J. L. SHEPHERD and Associates		
SCALE:	APPROVED BY: <i>[Signature]</i>	DRAWN BY: RMH
DATE: 18 NOV 69		REVISED: MFS
D.O.T. OVERPACK		
GEN'L CONCEPT		DRAWING NUMBER: A-0117-B

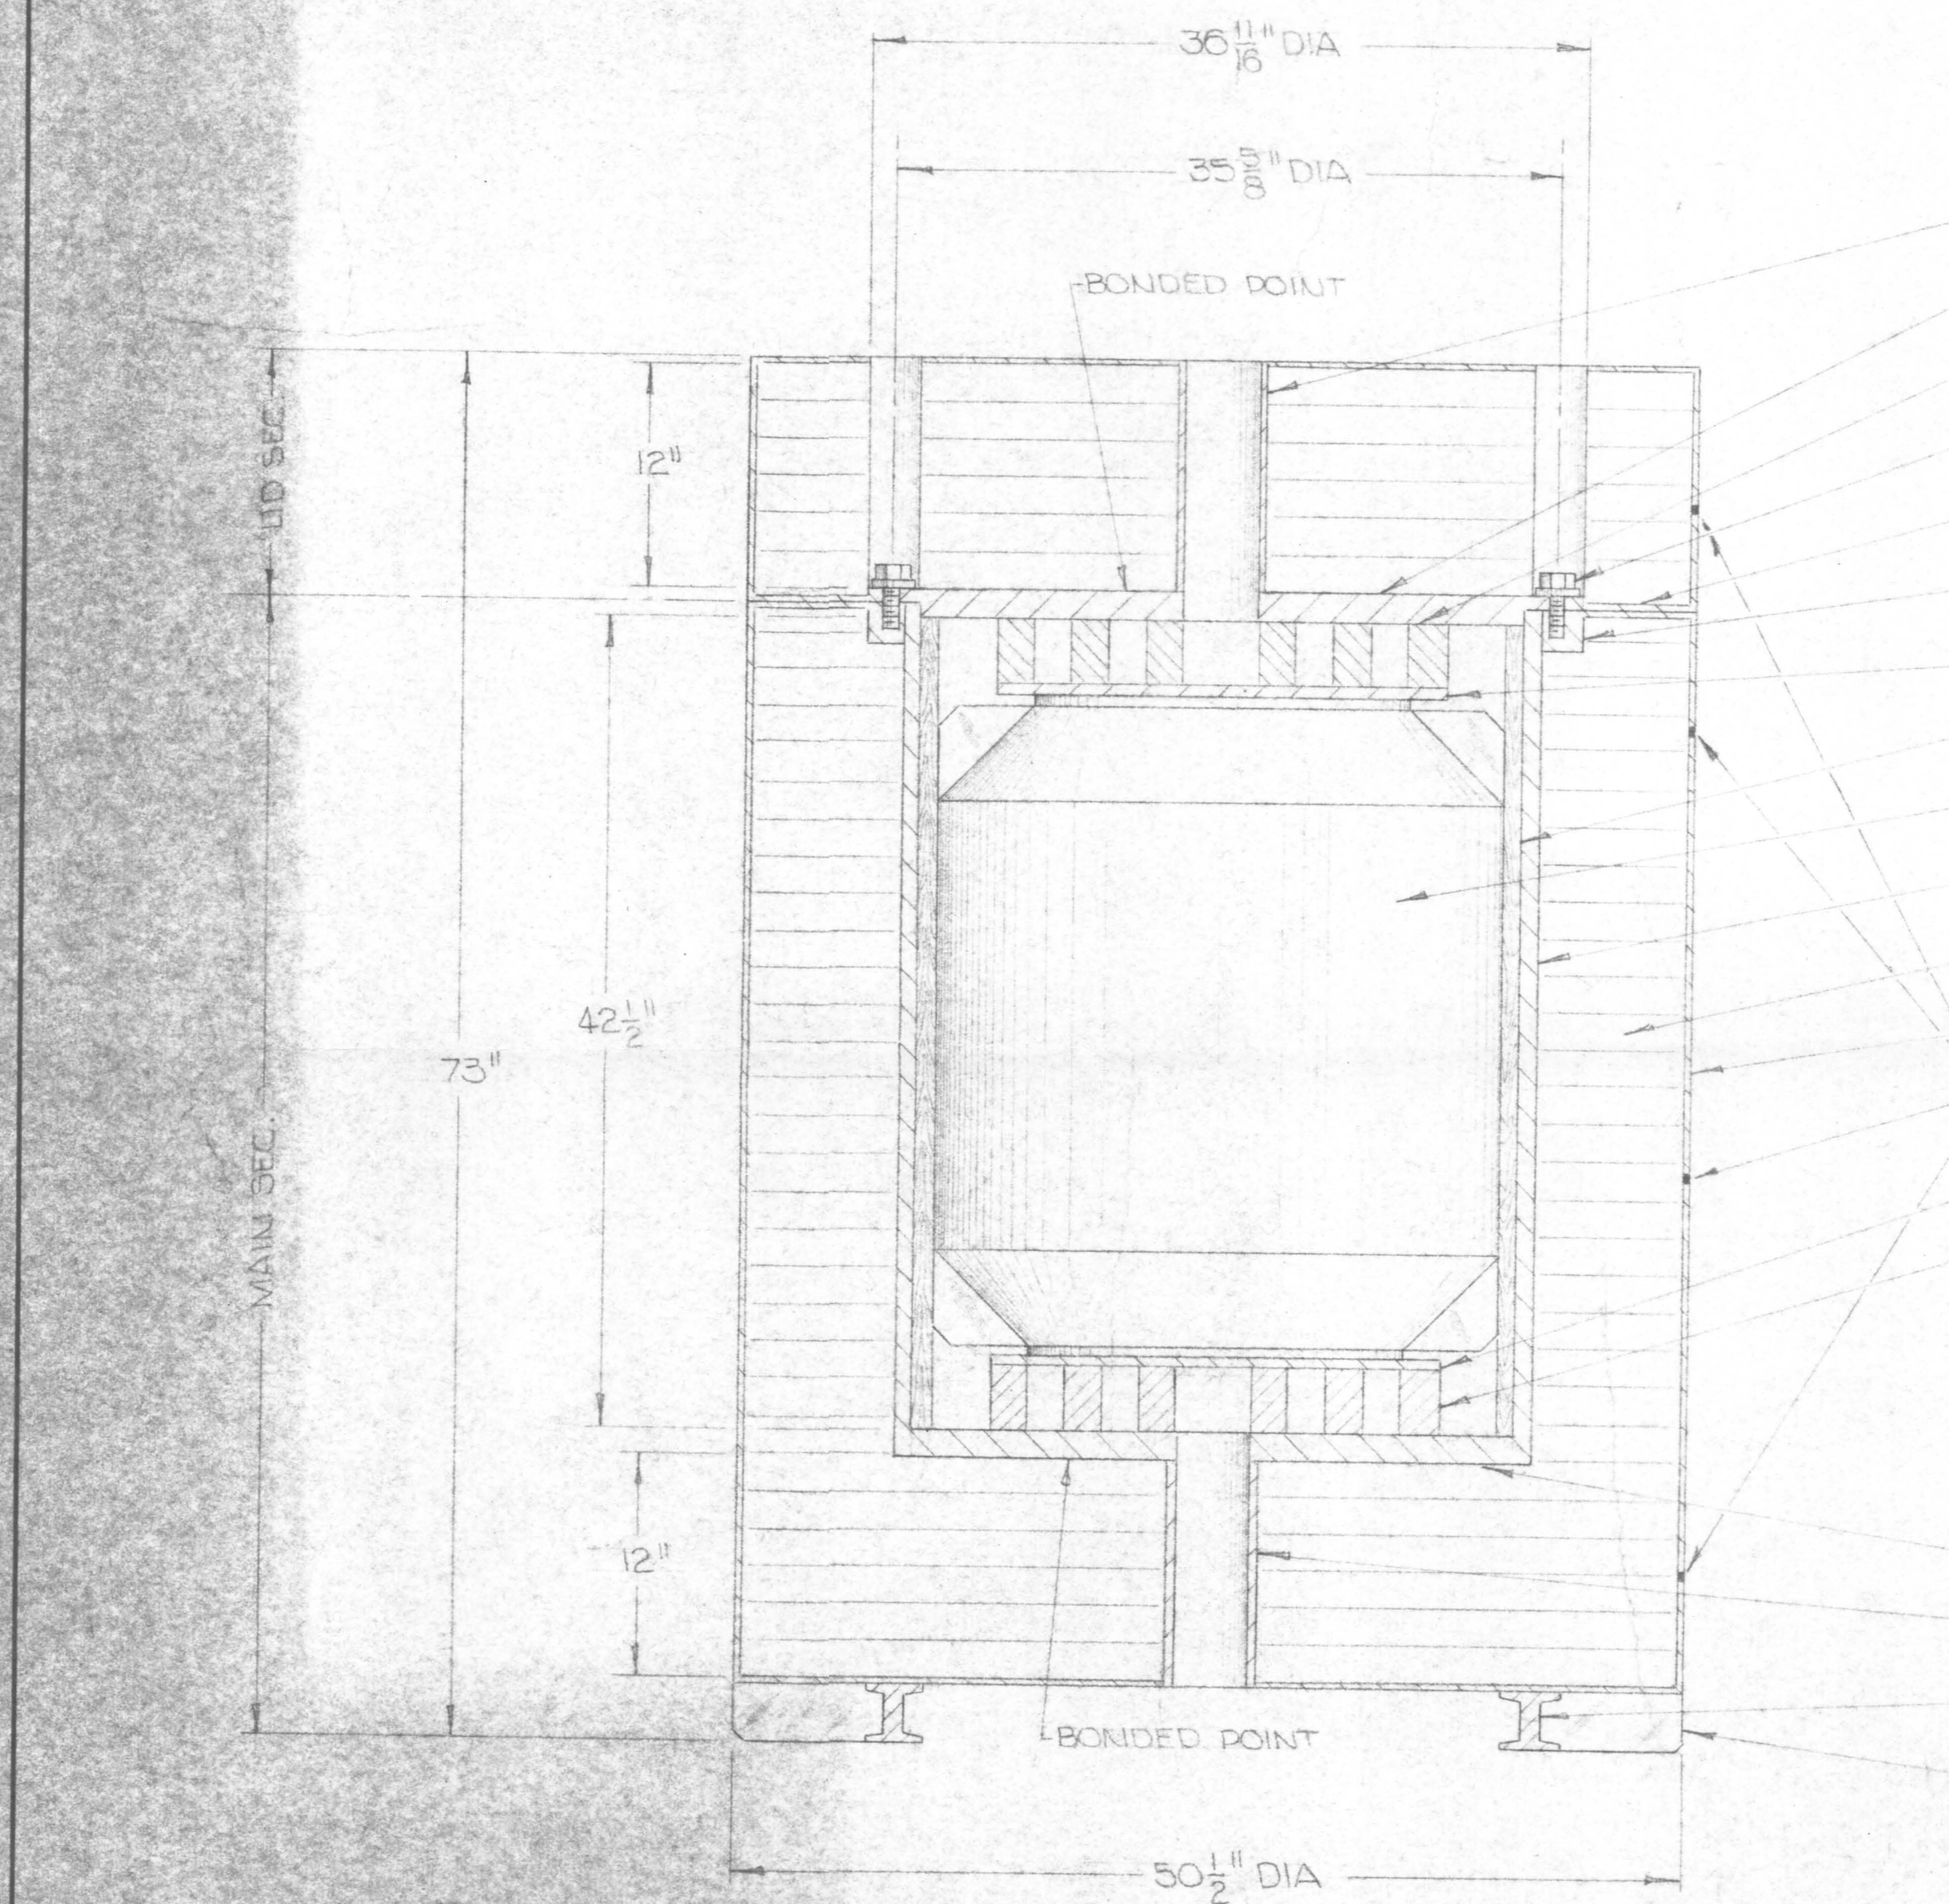
REVISIONS		
CHG A	4" STL PIPE TO 4 SCH 10 STL PIPE	2-10-70
CHG B	100% WELD TO 3/8 FILLET ALL AROUND	2-10-70
CHG C	10 LBS PER FT ³ TO 10-12 LBS PER FT ³	2-10-70
CHG D	1/8 EACH - 1/2" DIA. VENT HOLES-LOCATED IN 4 ROWS OF 4 HOLES EACH-PER CFR 178.194-2A(CB) 12 HOLES IN LOWER SECTION (MAIN BODY) OF OVERPACK-LOCATED 6" BELOW TOP, 6" ABOVE BOTTOM AND AT CENTERLINE. 4 HOLES LOCATED AT MIDPOINT OF UPPER SECTION (LID).
